Subject: **KIA 3.5L LAMBDA II OIL FILTER REPLACEMENT
vs. the 3.8L oil filter**

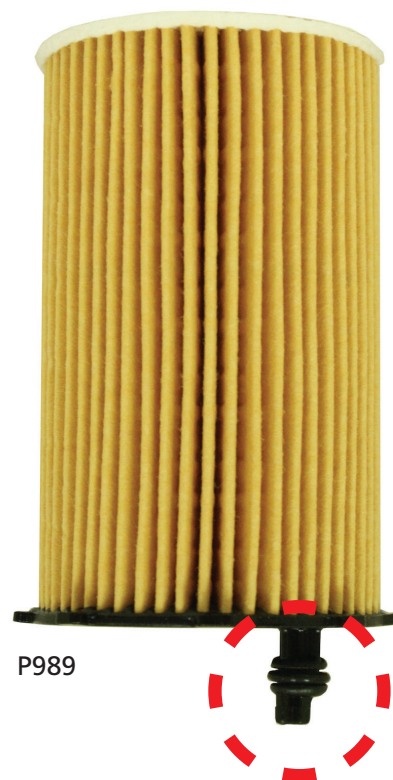
It is important to use the correct oil filter to avoid engine damage. While the 3.8L oil filter P982 appears similar to the 3.5L P989 filter, it is not interchangeable.

The 3.5L filter can be easily identified by the plastic post (see photo) on the bottom of the oil filter element. If the drain hole in the 3.5 L filter housing is not plugged by the post, loss of oil pressure can occur. Engine damage that is caused by the use of the incorrect oil filter is not covered under warranty.

This Champion Laboratories Inc. supplied oil filter P989 for the 3.5L Lambda II V6 engine must be used in this vehicle's service, specifically.
